**Coal Combustion Residue Impoundment
Round 9 - Dam Assessment Report**

Miller Steam Plant

*Coal Combustion Residue Impoundment Dike
Alabama Power Company
West Jefferson, Alabama*

April 2011

Photo 10: Vegetation on Downstream Slope of Saddle Dike 1

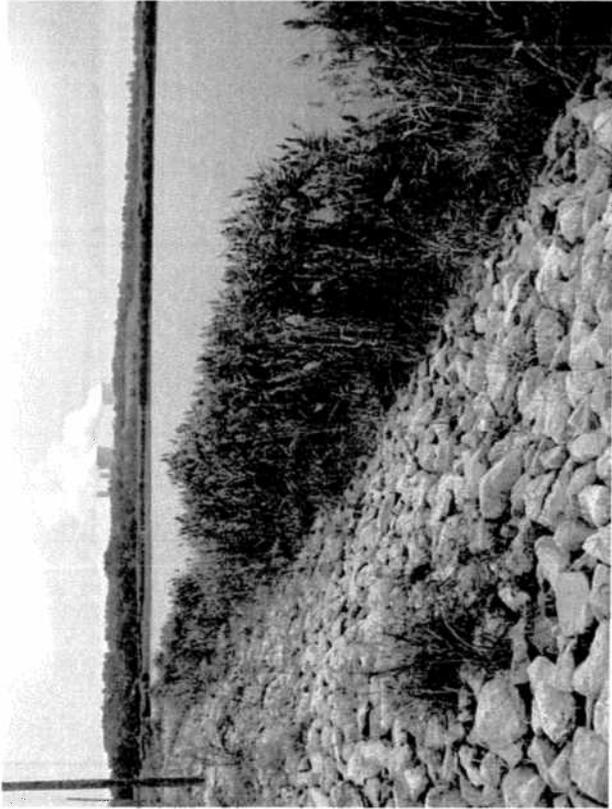
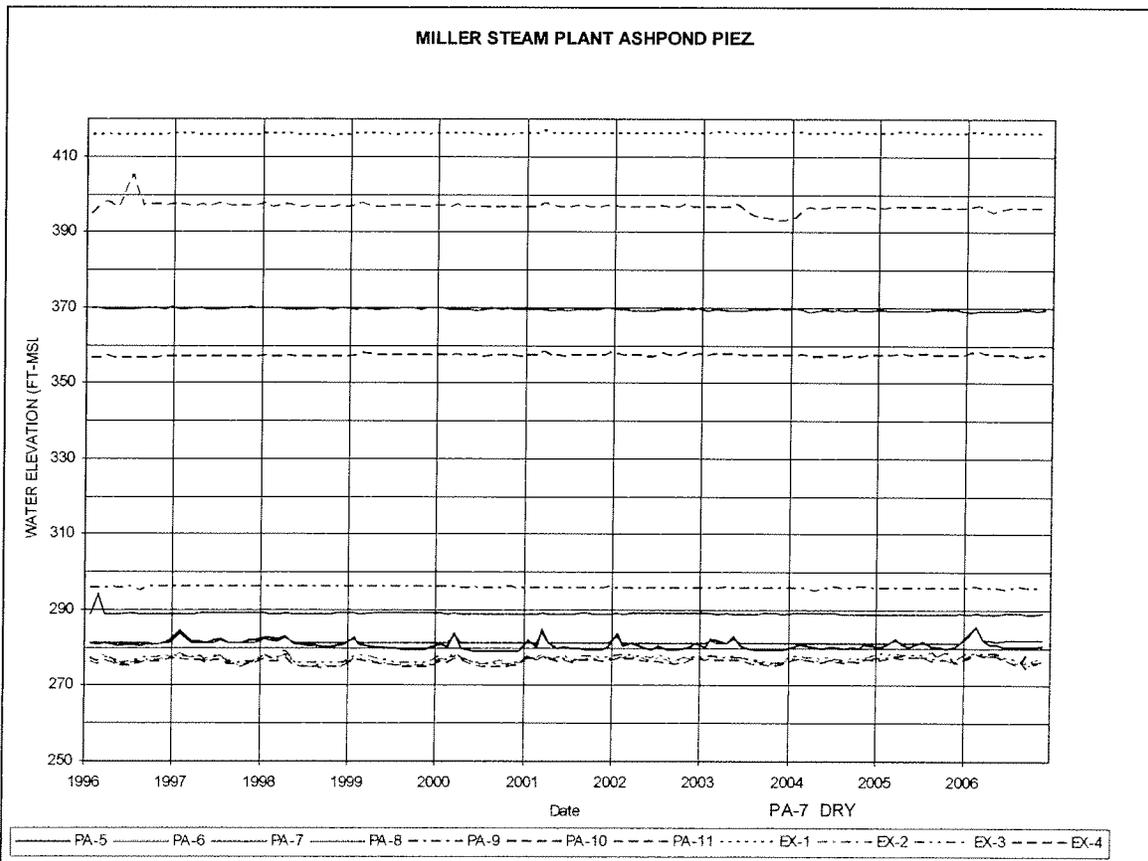
No.	Description	Location
1	The saddle dike should continue to be inspected and the vegetation on the embankment controlled.	Saddle Dike
2	The area around the spring outlets (Ash Pond STA 121+00) should continue to be kept free of brush and access to this area should be maintained	Ash Pond Dike (Photo 5)
3	Vegetation in the riprap along the upstream side of the ash pond dike crest should be removed and controlled by spraying herbicide.	Ash Pond Dike (Photo 11)

Photo 6: Erosion Along Ash Pond Dam Toe Access Road

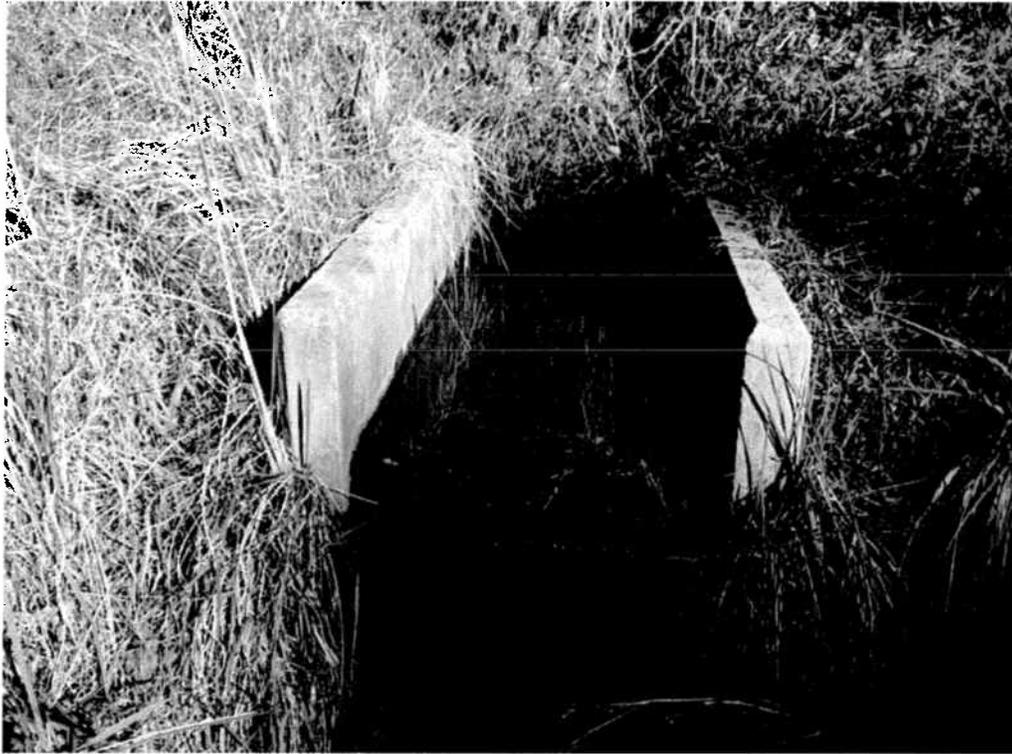
As a result of concentrated surface flows, significant rilling of the embankment toe access road was observed (see Photo #6). At the time of the inspection, it was recommended that the rilling be repaired to maintain the access for inspection, and it is the inspection team's understanding that this work has been completed. *It is recommended that future surface erosion of the access road be repaired as it is noted during the plant's regular dam safety inspections.*

- 2) It was recommended that future surface erosion of the access road along the embankment toe be repaired as it is noted during the plant's dam safety inspections. **Status: Completed. The deep rills noted in the roadway during the 2009 inspection were not observed during the 2010 inspection.**

Photo 8: Debris in Concrete Lined Drainage Ditch Along Saddle Dam Toe

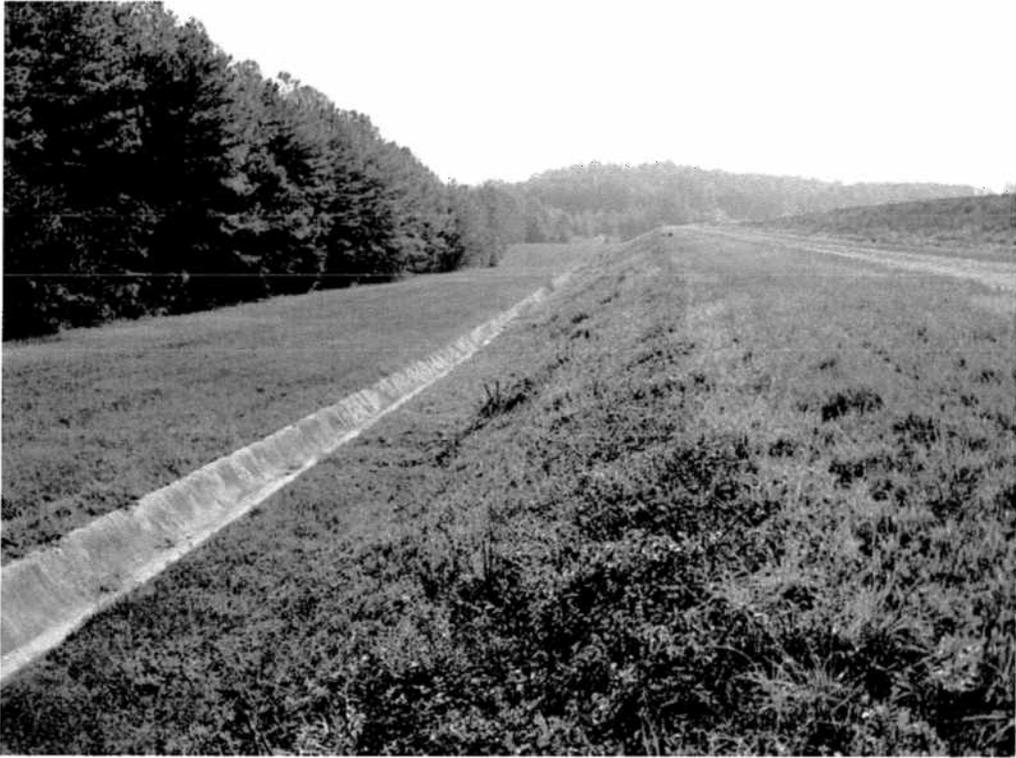
A portion of the concrete-lined drainage ditch had become clogged with debris (see Photo #8). ***As discussed above, it is recommended that the plant clear the debris from the drainage ditch so that it flows freely.*** It should be noted that this is not an urgent concern, but is suggested as a best practice.

No.	Description	Location
1	It is recommended that the current level of embankment maintenance at the main ash pond dam (on both the upstream and downstream slopes) be continued.	Main Ash Pond Dike (see Photo #4)
2	It is recommended that the plant staff clear the debris from the drainage ditches along the main ash pond dam embankment toe so that they are allowed to flow freely, and future maintenance efforts should include provisions to keep them clear.	Main Ash Pond Dike
3	It is recommended that the current level of embankment maintenance be maintained at the saddle dike.	Saddle Dike (see Photo #7)
4	It is recommended that the plant clear the debris from the drainage ditch along the saddle dike embankment toe so that it flows freely.	Saddle Dike (see Photo #8)
